Federal Communications Commission
Authorization and Evaluation Division
7435 Oakland Mills Road
Columbia, Maryland 21046

Please find attached our reply to your correspondence concerning LJPNSB-7 (EA97165, correspondence reference number 13864). The original text is followed by our highlighted response.

Applicant: Nokia Mobile Phones

FCC ID: LJPNSB-7

Picture 1. Separation distance when using SKB-2

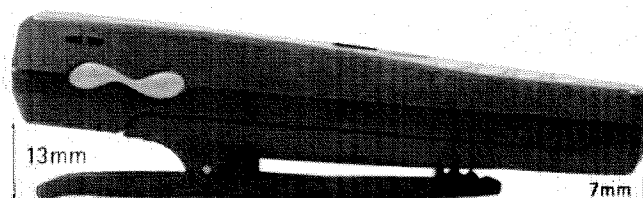
3. Provide the separation distance used while testing for body-worn data with the _belt clip against the flat phantom_ data.

Separation distance is 13mm at the antenna side and 7mm at the bottom side. This is shown in picture 1.
